STATE OF ALASKA
DEPARTMENT OF TRANSPORTATION AND PUBLIC FACILITIES

Hoonah Alaska

GENERAL LAYOUT

PROJECT NUMBER X 70006 SHEET 2 OF 6

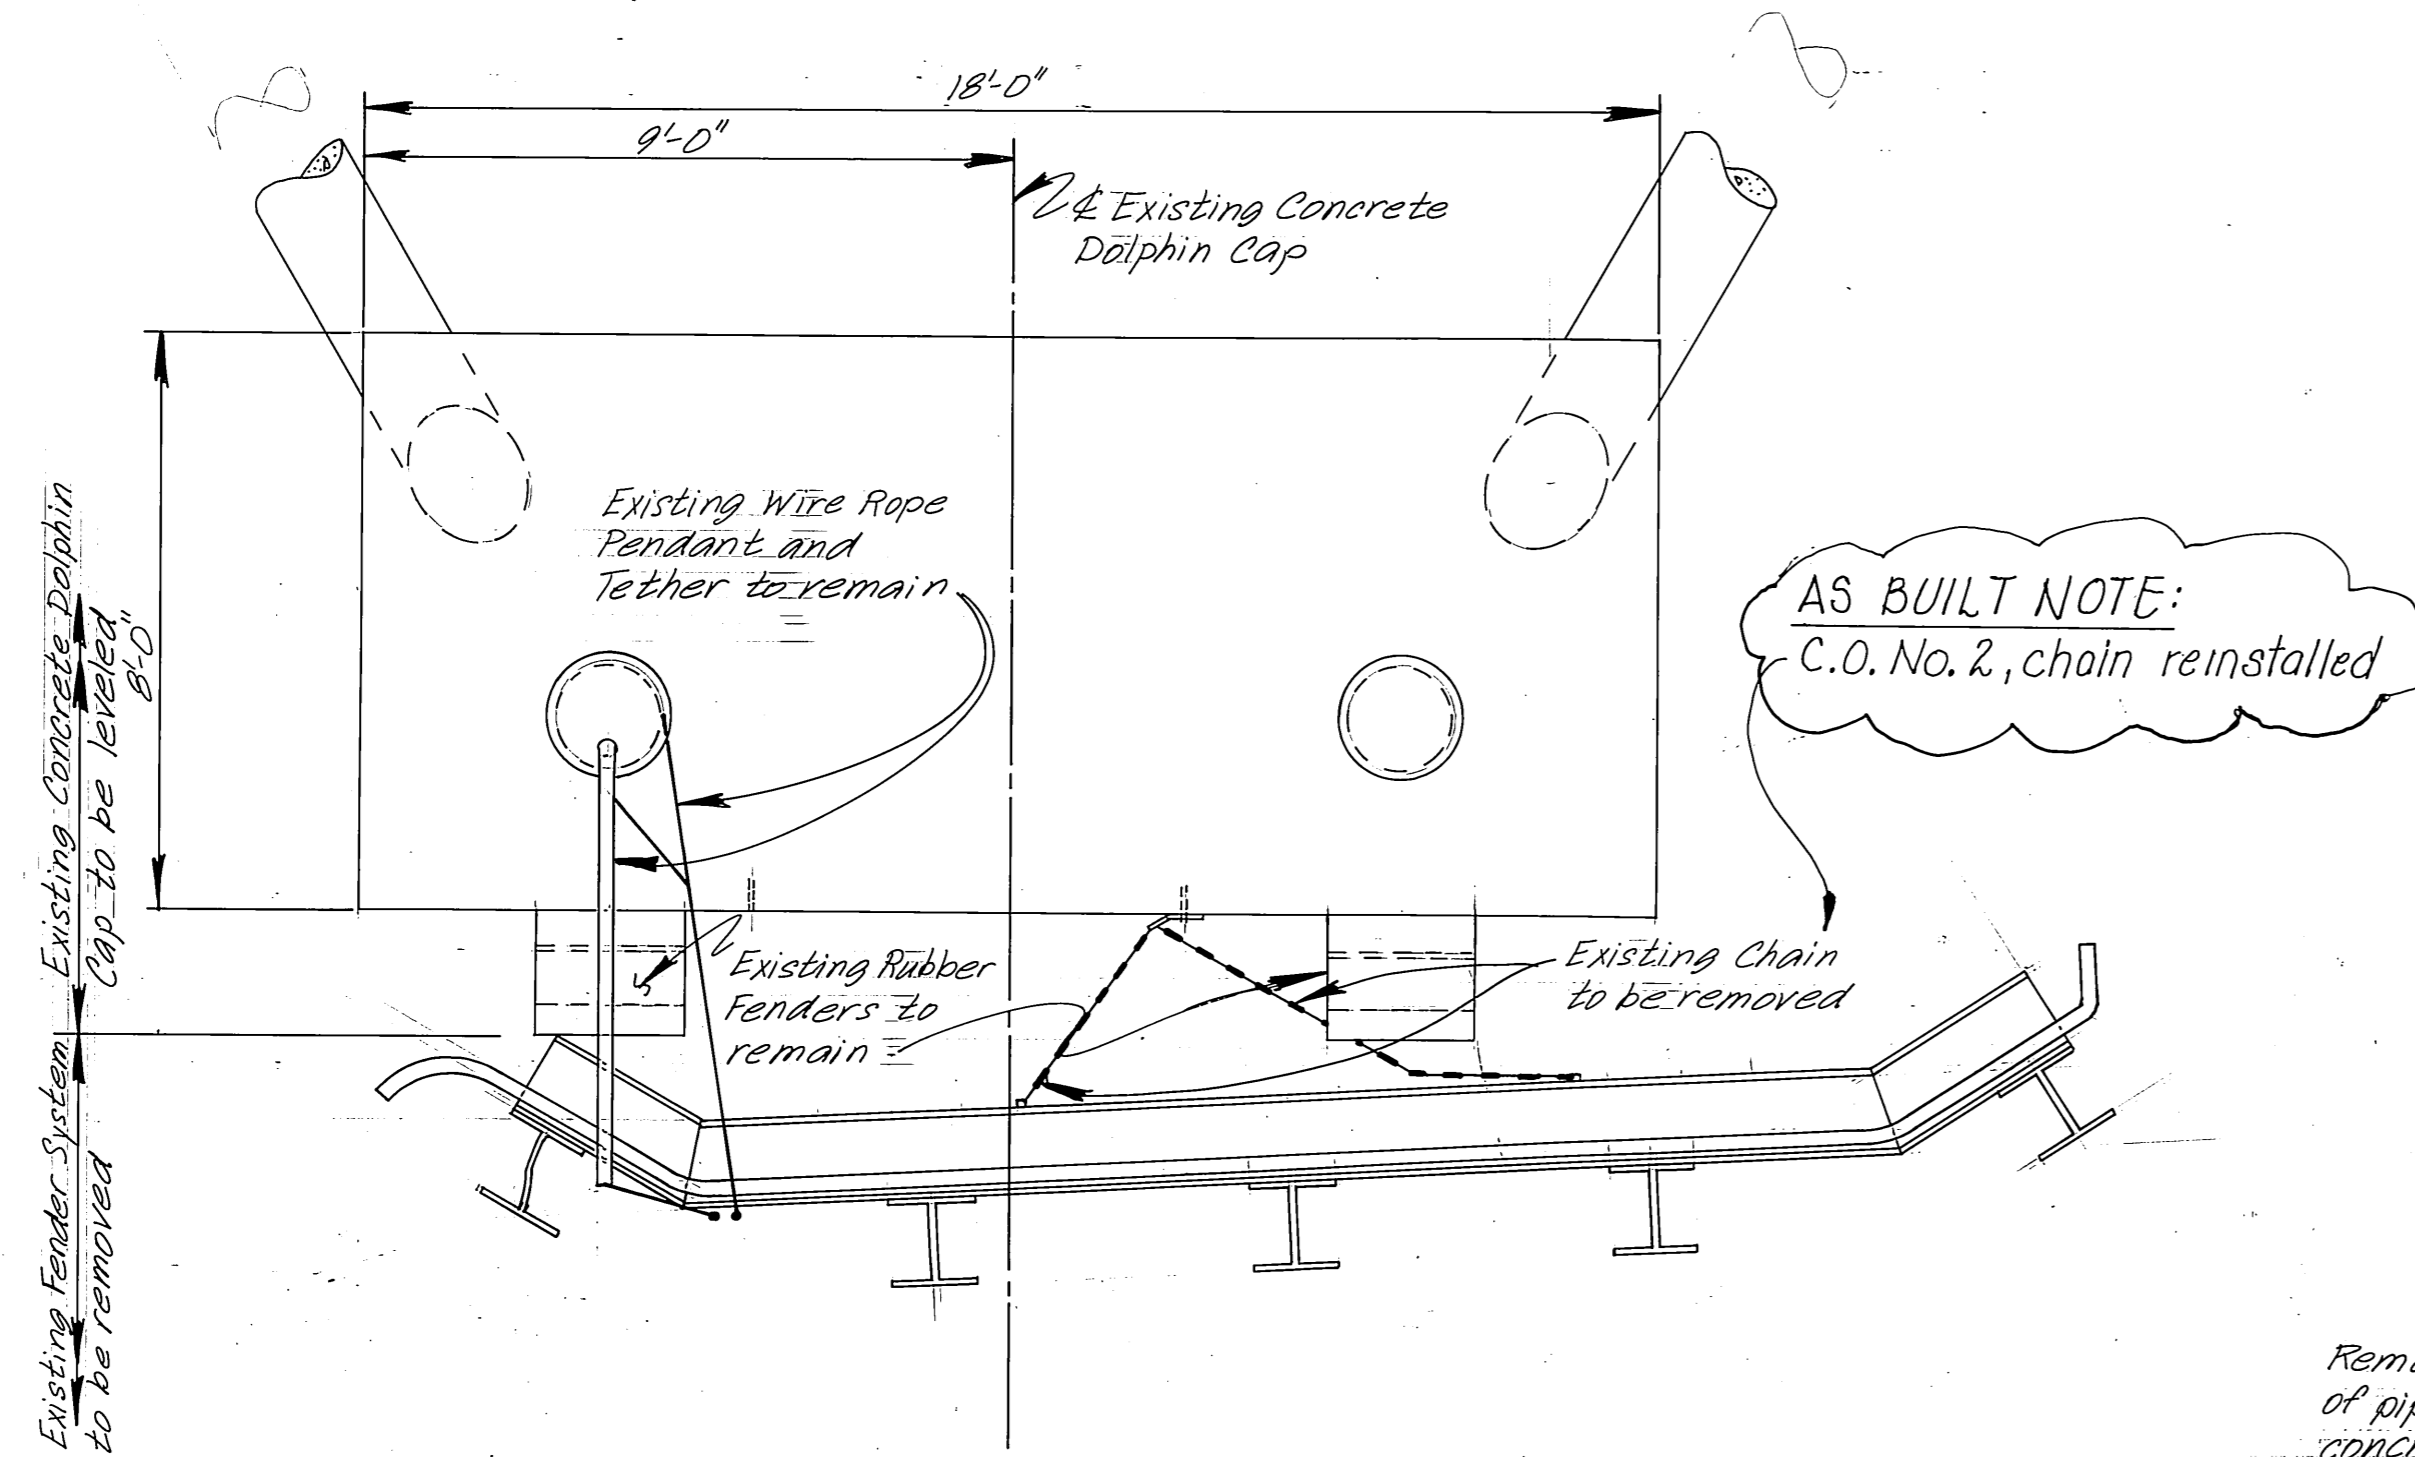
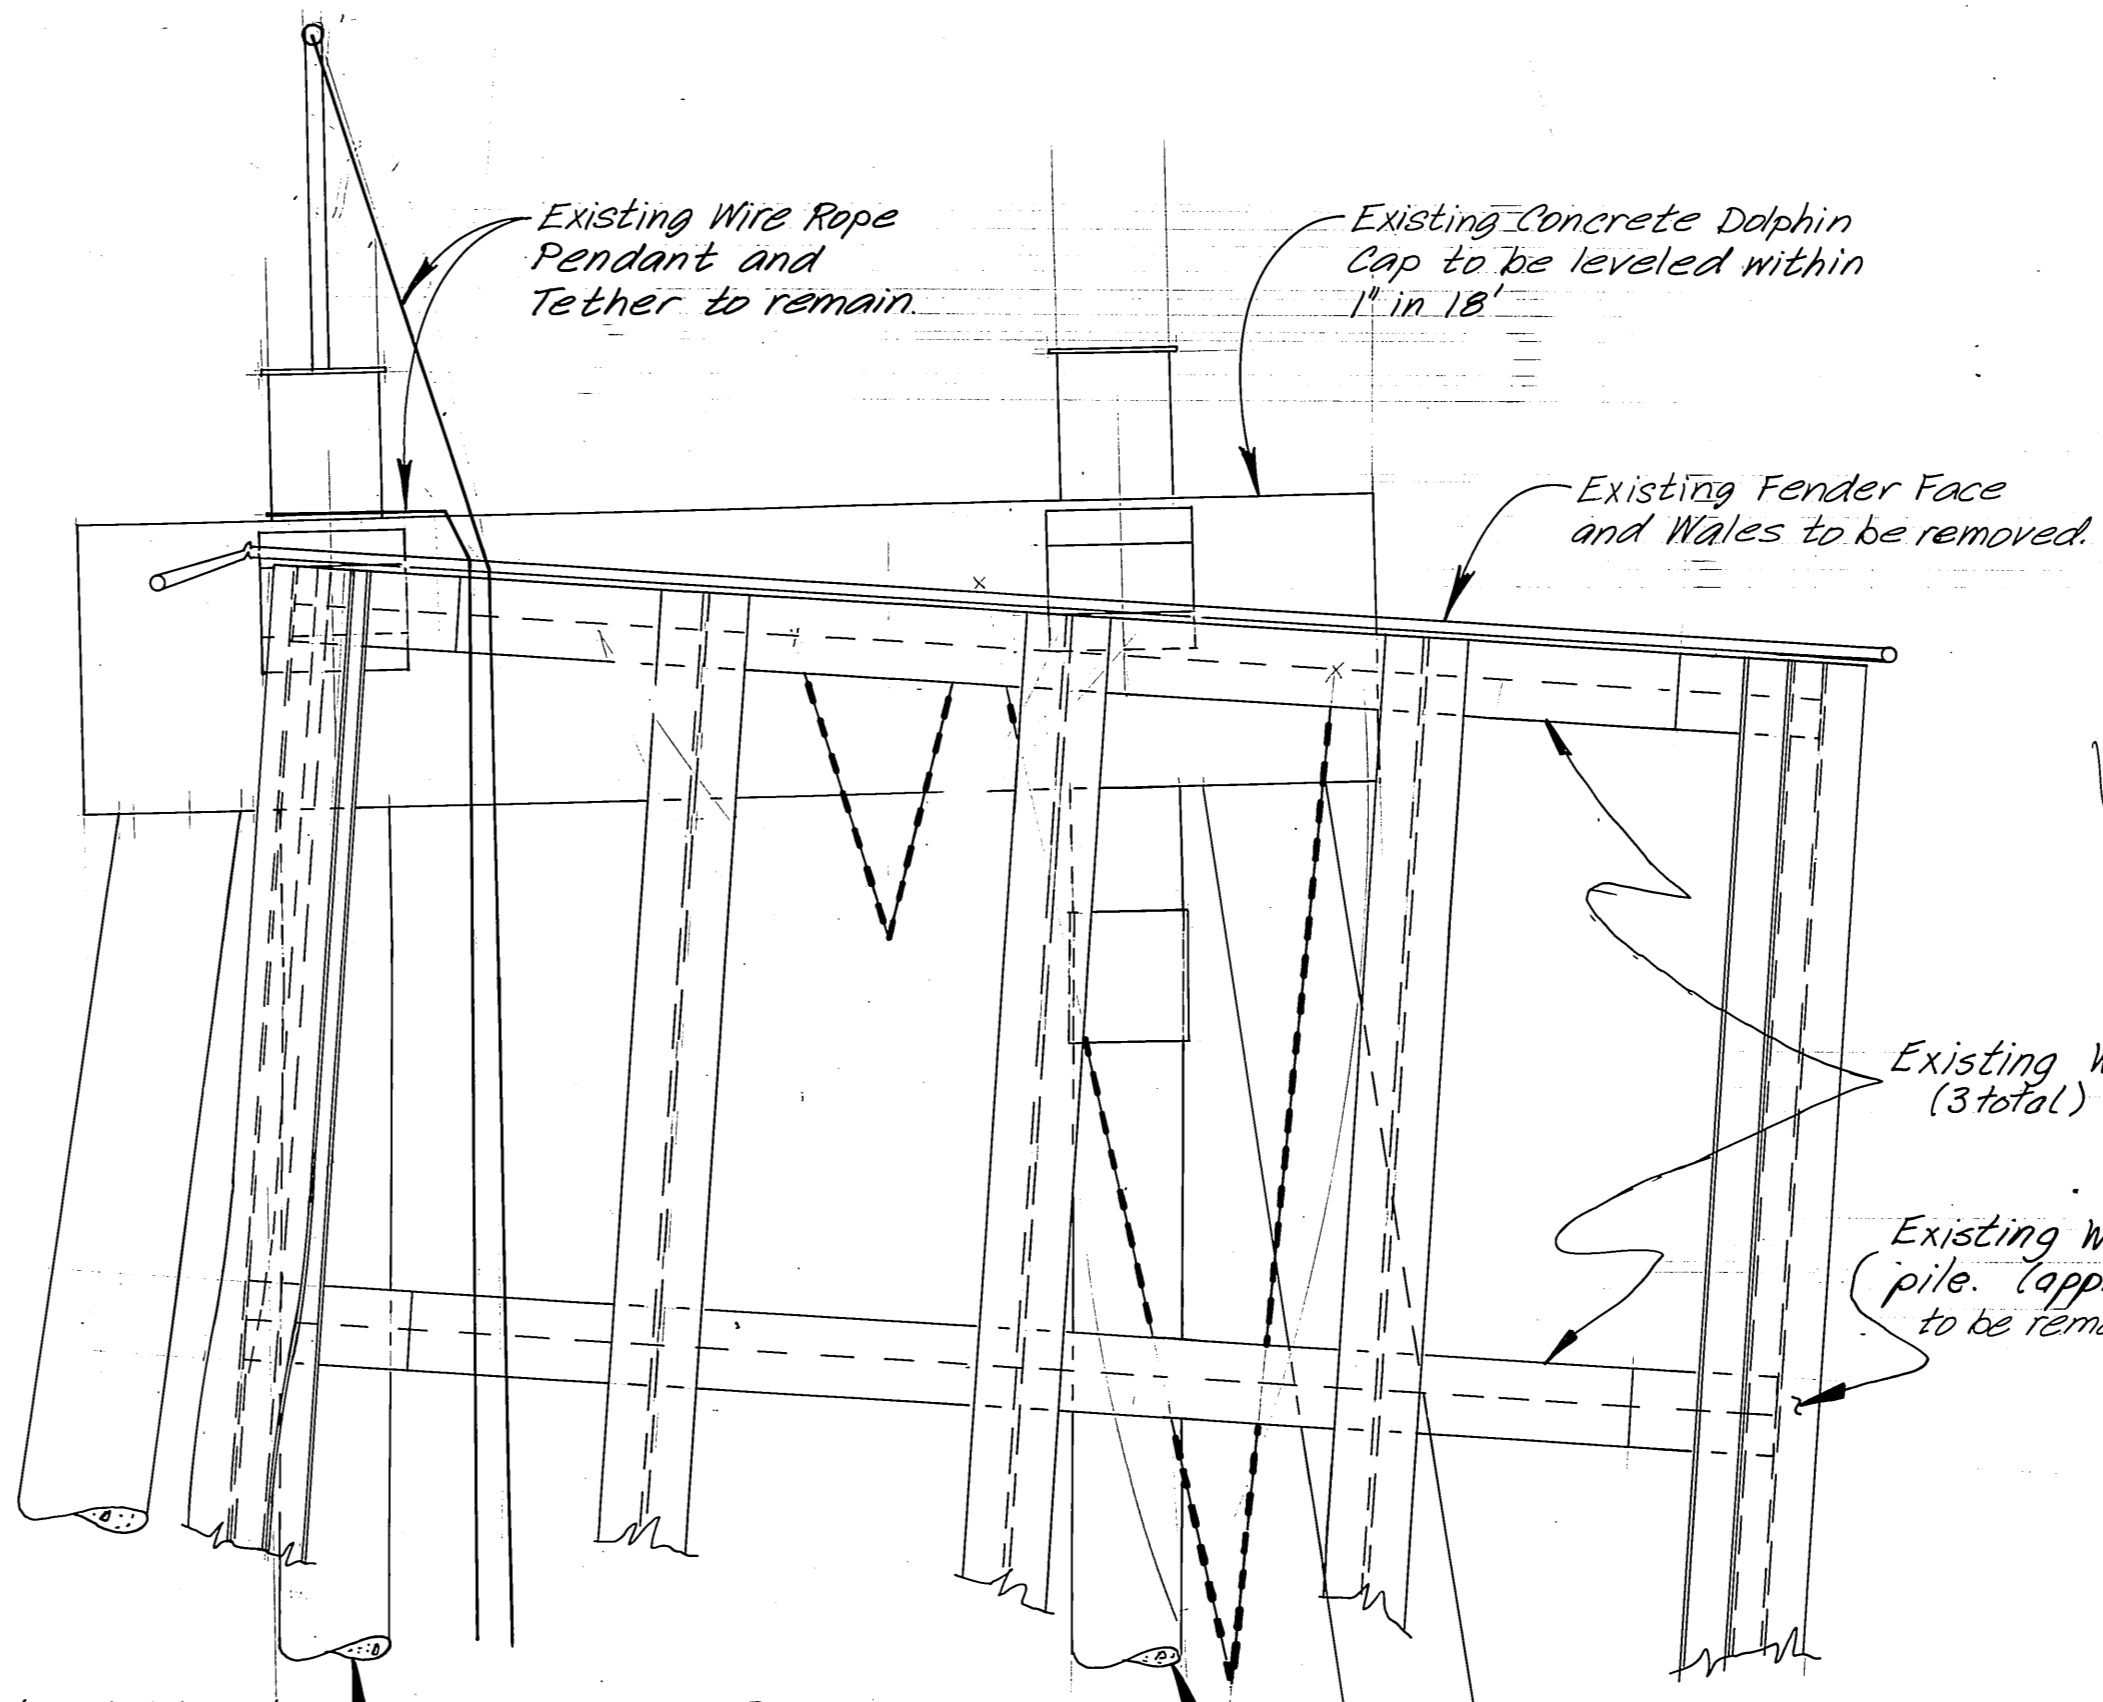
Note: Existing 4x12 face timbers on pile flanges not shown. These to be replaced. ~~See Note 3 on sheet 3~~ awarded. See Note 3 on sheet 3.

As Built Note: Supplemental not awarded

1/22/85		DO NOT SCALE THIS DRAWING - USE DIMENSIONS	
STAMP		STATE OF ALASKA	
		DEPARTMENT OF TRANSPORTATION AND PUBLIC FACILITIES	
		Alaska	
Hoanah		FENDER PLAN & ELEVATION	
DESIGNED LVB	CHECKED JS	DRAWN LVB	DATE 10/84
PROJECT NUMBER X70006	SHEET 3		OF 6

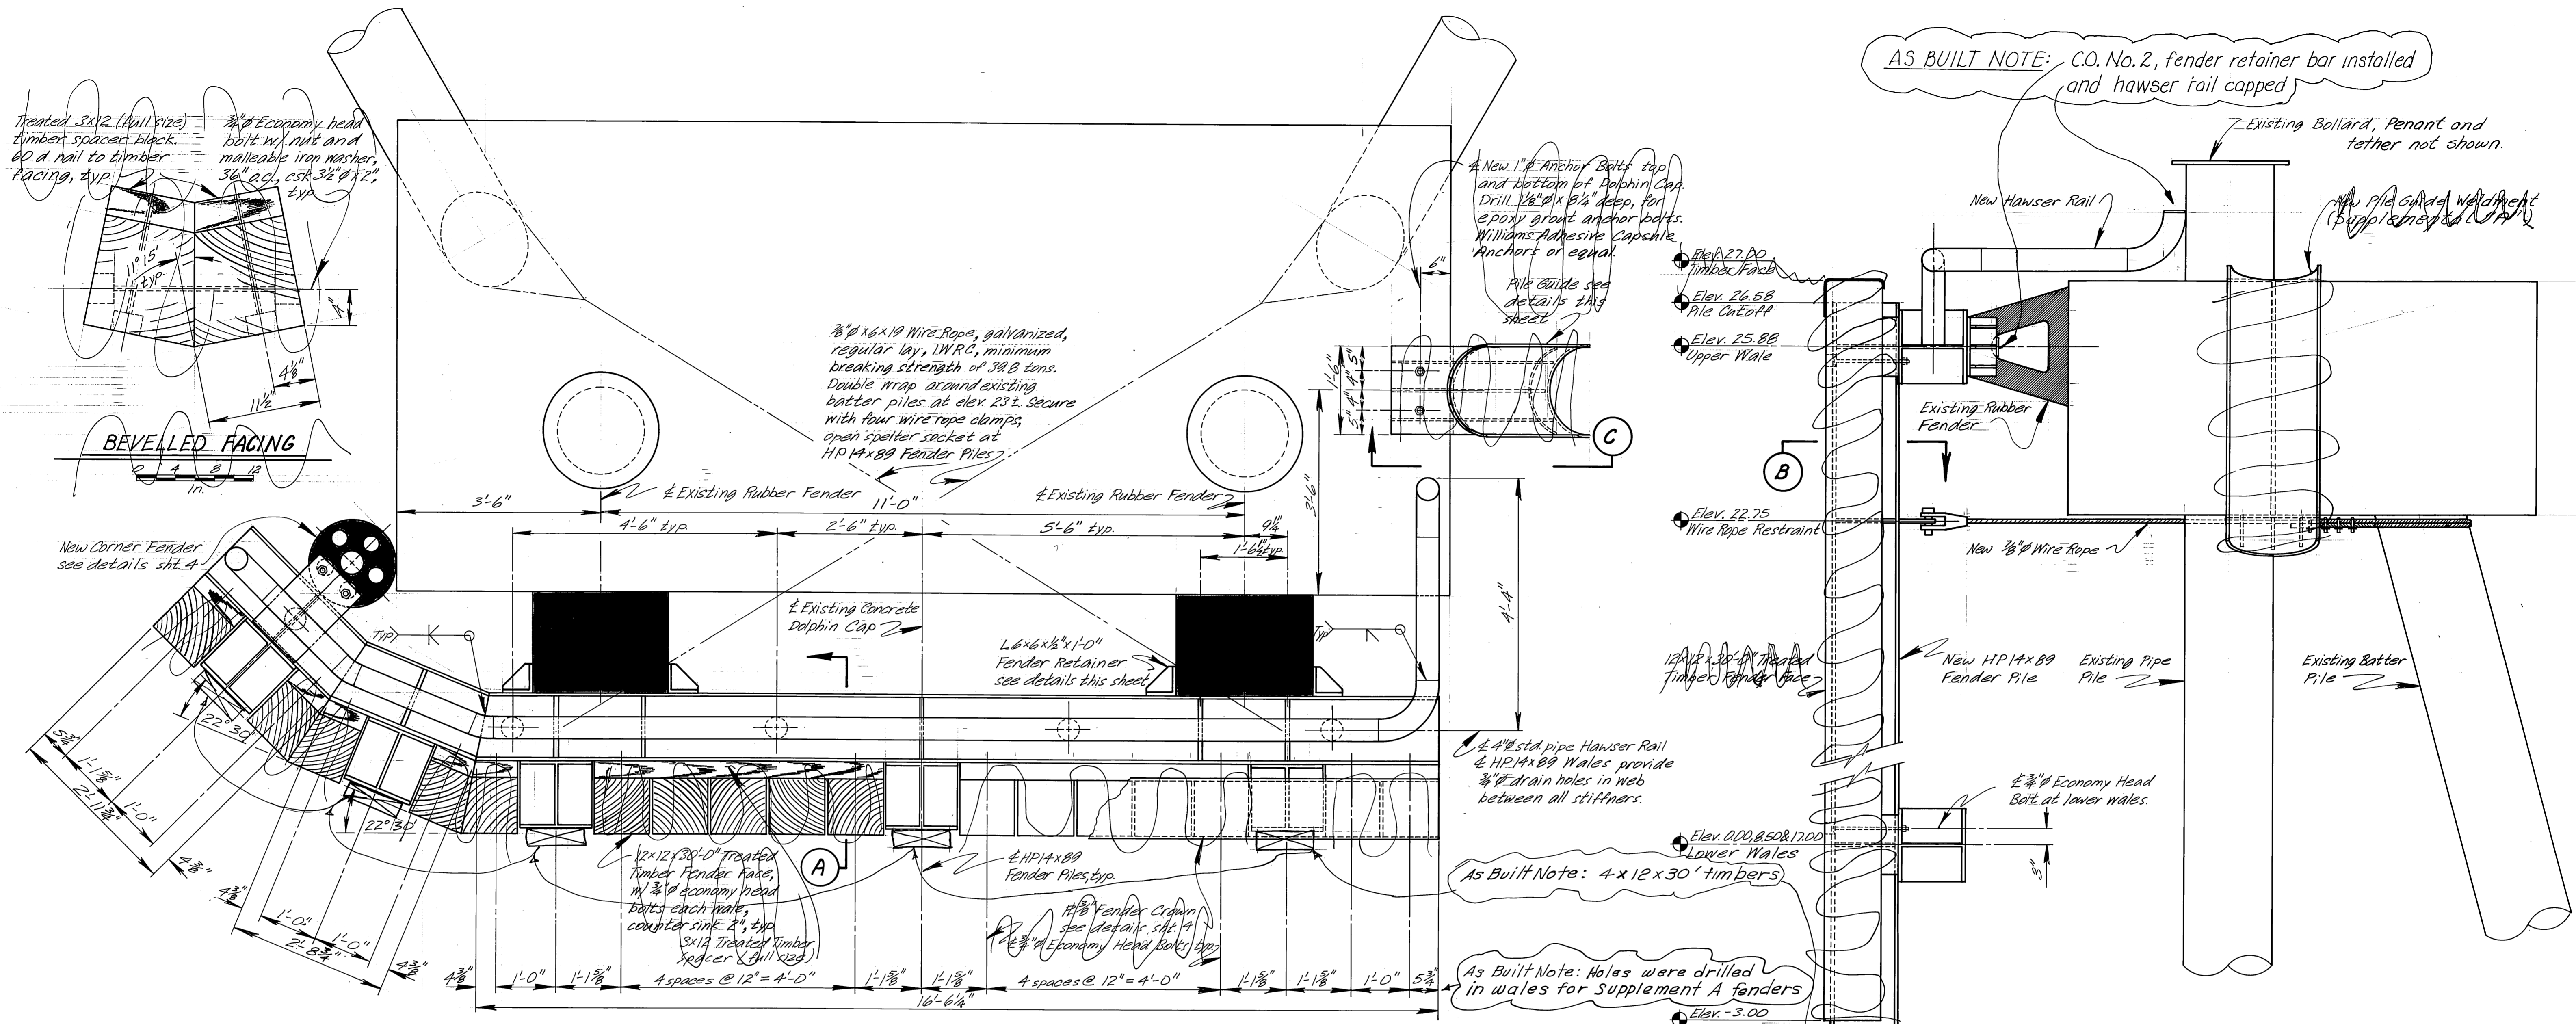
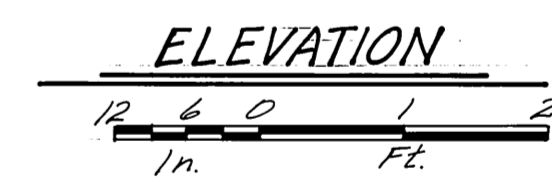
AS BUILT NOTE: 4 x 12 x 30' timbers

AS BUILT NOTE: Holes were drilled in wales for Supplement A fenders

AS BUILT NOTE: C.O. No. 2, fender retainer bar installed and hawser rail capped

As Built Note: 4 x 12 x 30' timbers installed on face of piles
